**RE: Durango Unit 3**  
**Request for Partial Pad Certification Lots 1-26, 28-37 - Approved**  
**Grading Plan Stamp Date: 8/12/15**  
**Certification Dated: 2/1/21**  
**Drainage File: C09D012**

Re: Partial Grading and Drainage Certification (Lots 1-26, 28-37) Durango Unit 3 Subdivision;  
DRB Case No. PR- 2018-001996; Hydrology File C09D012

DURANGO  
UNIT 3  
GRADING AND DRAINAGE PLAN

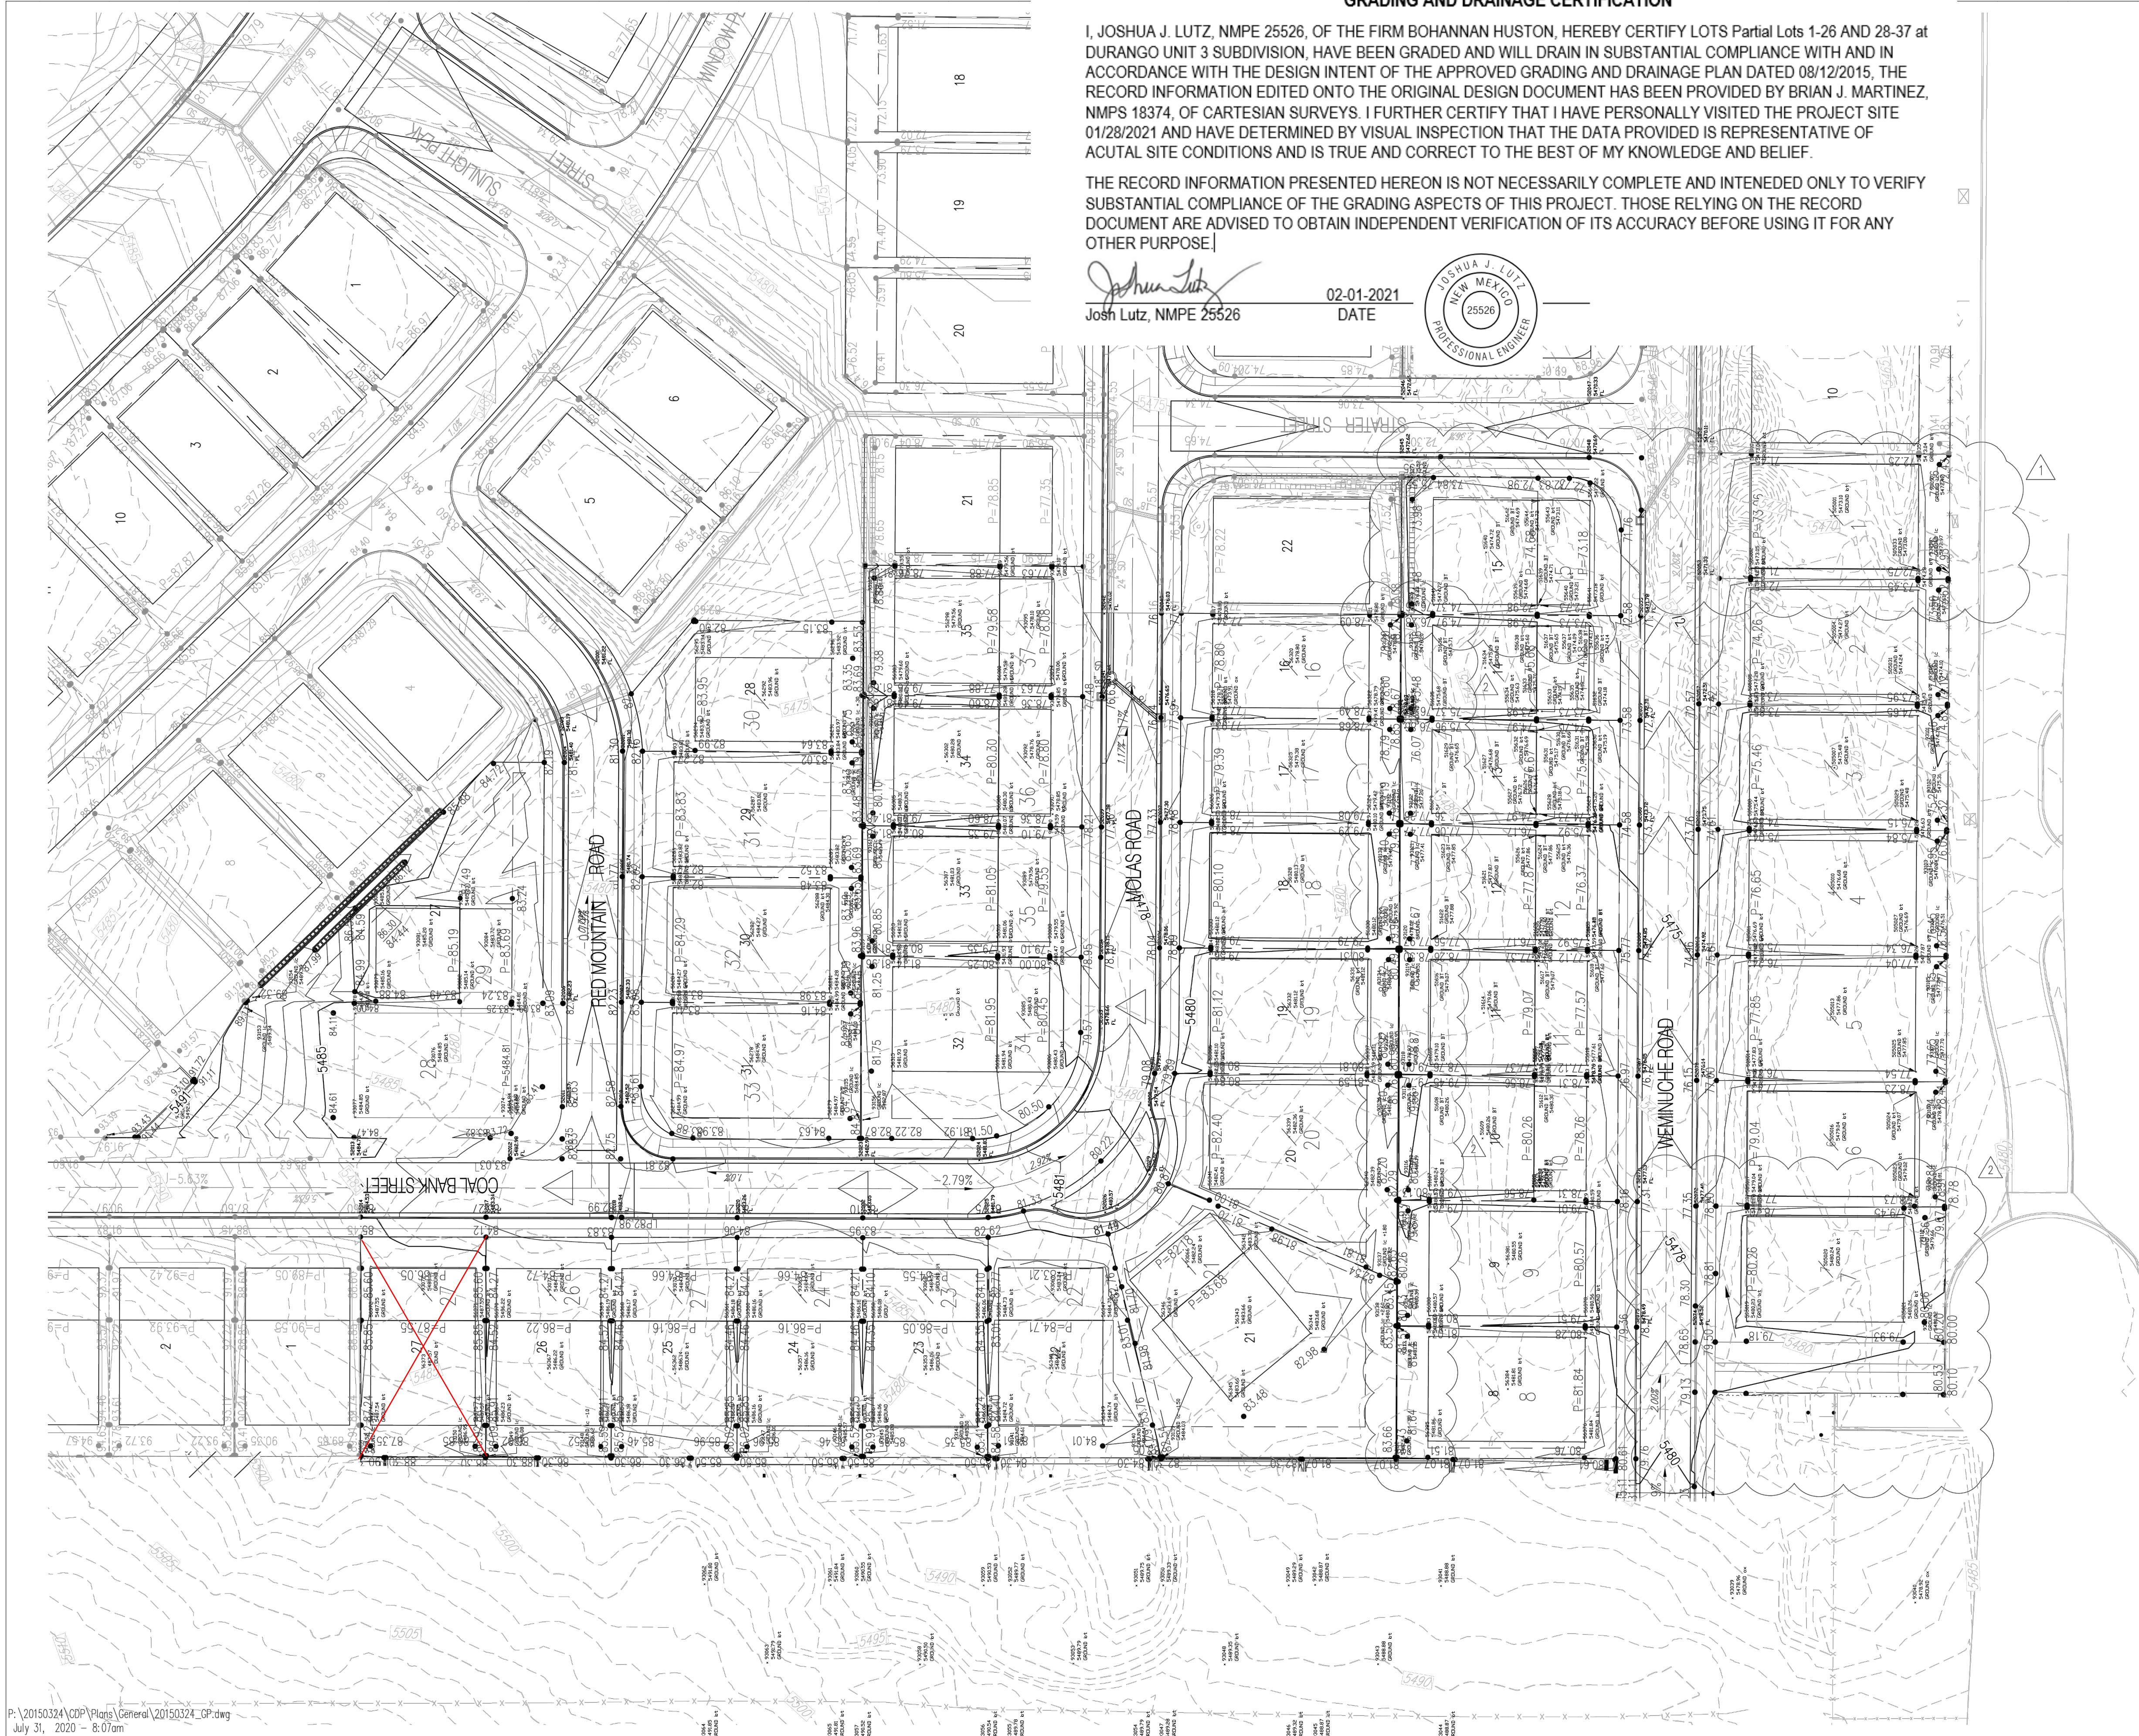
Based on the submittal received on 2/2/21, this certification is approved for Building Permit for the lots listed above.

Please note, Certificate of Occupancy will be held until Infrastructure improvements are complete.
